Docket Item # 3 & 4
BAR CASE # 2011-0125 & 0126

BAR Meeting
June 15, 2011

ISSUE: Permit to Demolish/Encapsulate and Alterations

LOCATION: 317 South Lee Street

Figure 1: Existing and proposed site plan.

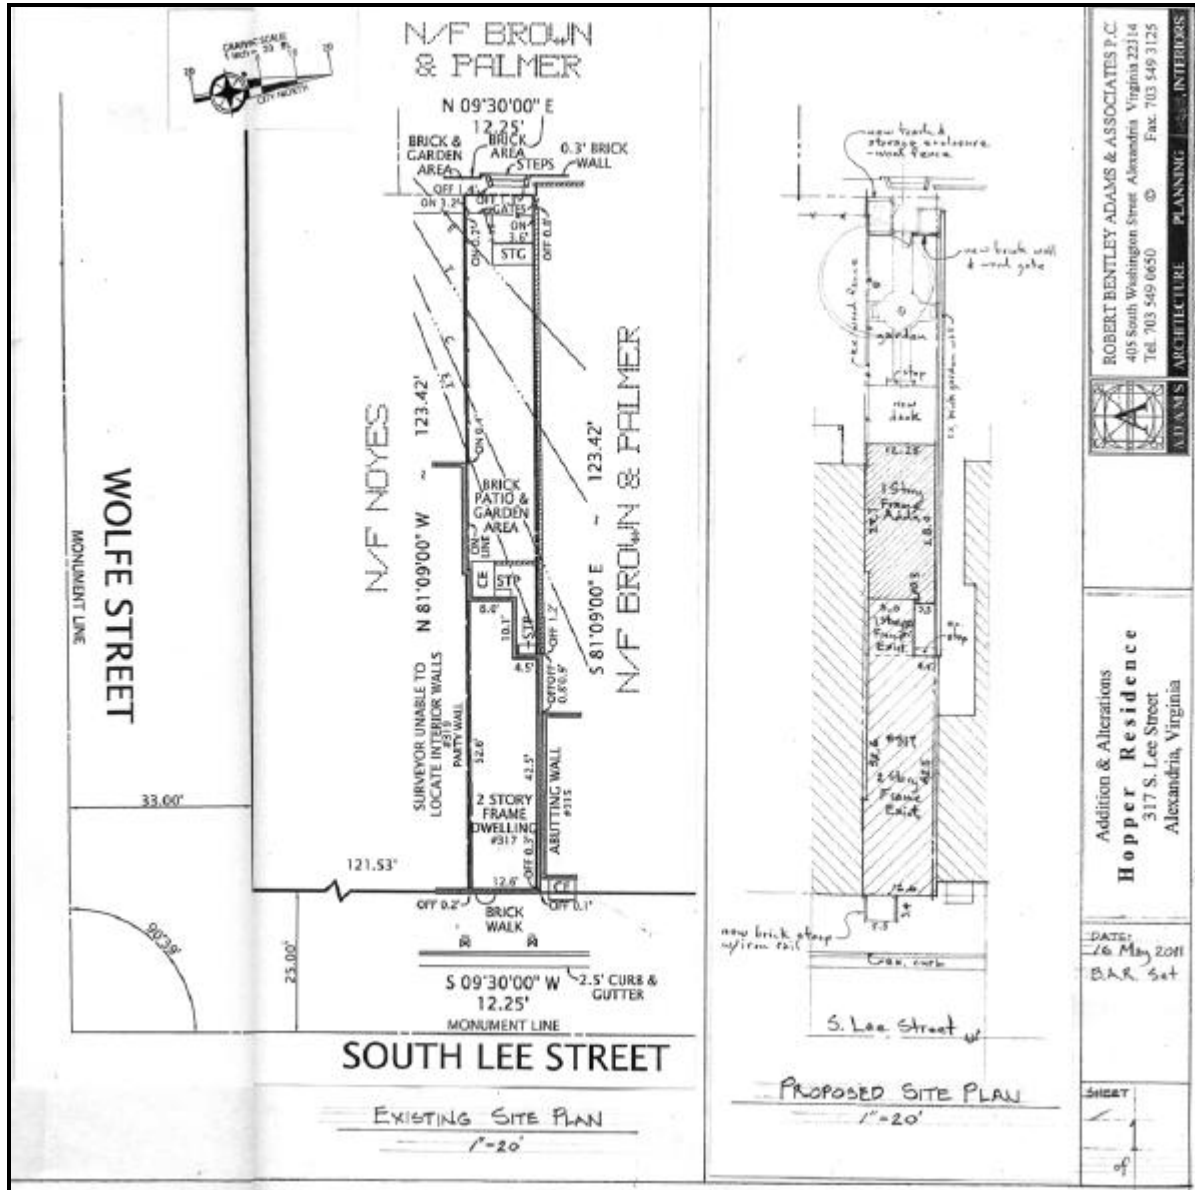
F-1 The proposed site plan submitted with the BAR application shows a one story addition 28 x 12.25 feet at the rear of the existing structure, however this information is not indicated on the application under "nature of proposed work" (check all that apply)

Figure 2: Rear elevation showing proposed demolition/encapsulation.

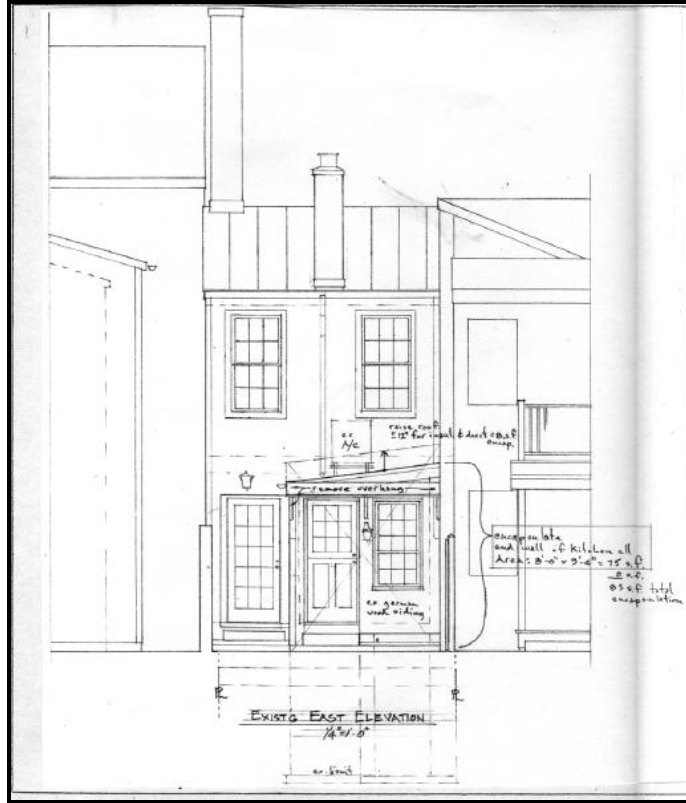
Staff has no objection to the proposed demolition and encapsulation of a small portion of the existing kitchen ell, noting that the current rear addition configuration likely dates to the mid-twentieth century. Furthermore, Staff supports the installation of a new stoop at the front entrance to the house, provided that the stoop projects no more than 3 feet into the public right-of-way, as allowed by the City Code without an encroachment for a 50' wide right-of-way.

In the opinion of Staff, none of the criteria for demolition and encapsulation are met and the Permit to Demolish/Encapsulate should be granted. Staff finds that the proposed demolition and encapsulation do not compromise the integrity of this townhouse as the areas of demolition and encapsulation are located on a secondary elevation not visible from a public right-of-way and modest in scope.

Figure 7: Proposed front stoop elevation and section.

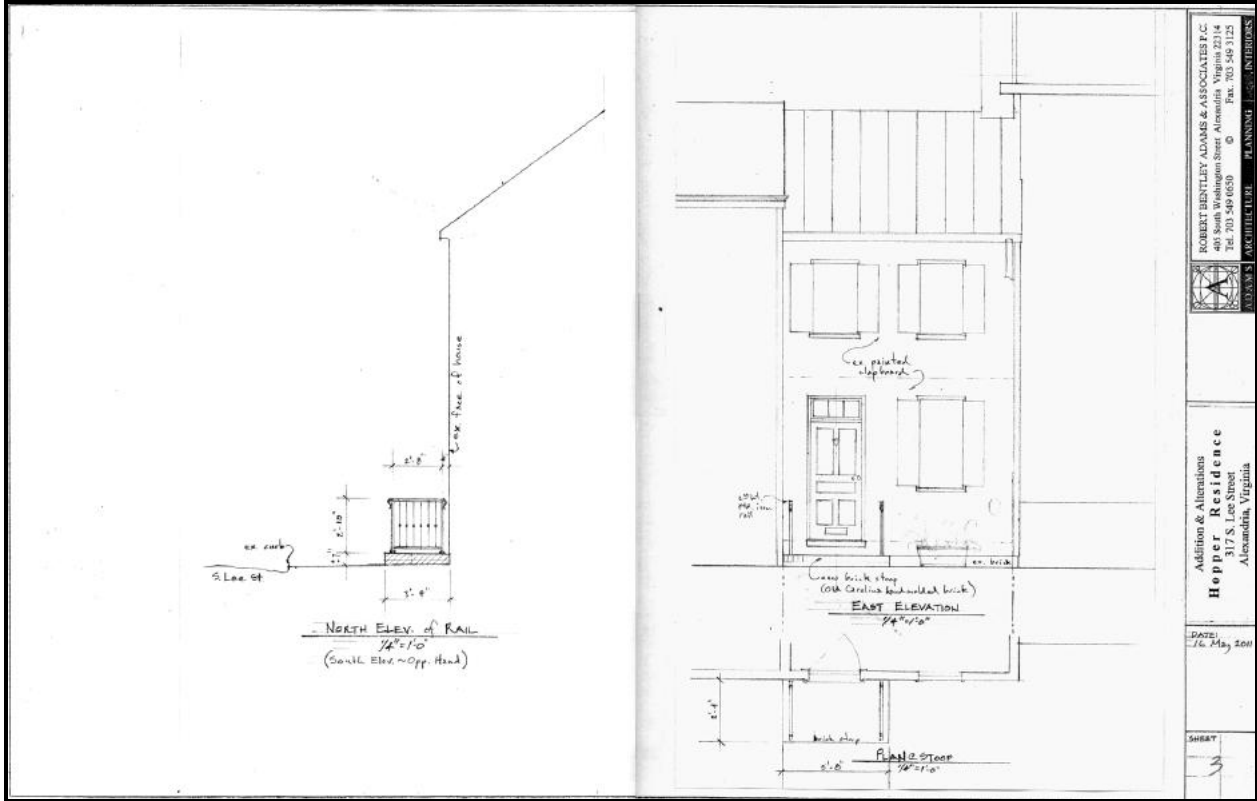
The applicant also proposes to demolish the existing curved stoop at the entrance to the property and construct a new brick stoop with simple painted iron railings. The stoop will project 3'-4" into the public right-of-way.

In the opinion of Staff, the proposed front stoop complies with the recommendations contained in the *Design Guidelines* for Stoops, Steps & Railings, which state that they "...should be appropriate to the historic style of the structure." The stoop and railings will be simple and subtle, are similar to nearby residences and will not compromise the integrity of this vernacular frame townhouse.

Staff recommends approval of the application, provided that the stoop projects no more than three (3) feet into the public right-of-way.

- C1. Steps not more than 12 feet in length, including the required landings, may project beyond the street lot line up to five feet on streets with a right-of-way width of 100 feet or more, up to four feet on streets with a right-of-way width between 66 and 100 feet, up to three feet on streets with a right-of-way width between 50 and 66 feet and, notwithstanding the above, up to 20 inches on Union Street and on King Street between the Potomac River and the R.F.& P. railroad right-of-way. (Sec. 5-2-29 (a)) (T&ES)

1. That the front stoop project no more than three (3) feet into the South Lee Street public right-of-way; and,
2. That the statements in the archaeology conditions below appear in the General Notes of all site plans and on all site plan sheets that involve demolition or ground disturbance (including Basement/Foundation Plans, Demolition, Erosion and Sediment Control, Grading, Landscaping, Utilities, and Sheeting and Shoring) so that on-site contractors are aware of the requirements:
